Staff Report

Re: PLNHLC2025-00555, 228 Townhomes

New Construction

PROPERTY ADDRESS: 228 W 600 N

West (Interior Side) Elevation

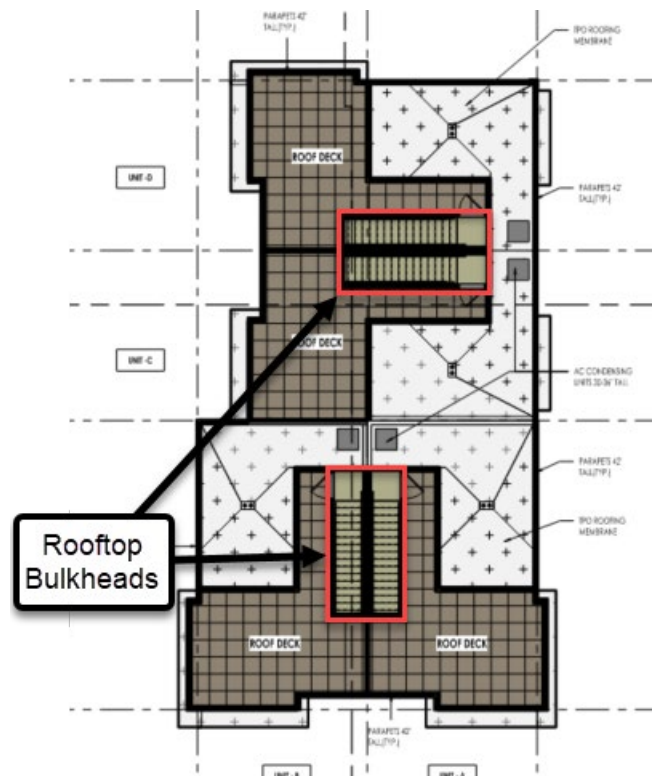
The applicant modified the roof pitch and height of the bulkheads and added small windows to break up the blank facades. The modifications effectively reduced the scale and visually integrated the structures into the overall design of the building which is more compatible with the historic context.

The initial design of the window patterns, scale, solid to void ratio, and orientations on portions of the east and west facades lacked a rhythm and were not consistent with the primary facades or the historic context. The applicant modified the patterns, solid to void ratio, scale, and orientations of the windows to create a rhythm of openings consistent with the primary facade of the structure which also relates with the historic context. The initial slider windows were also replaced with double hung windows which divide larger openings on the secondary facades and create appropriate proportions.
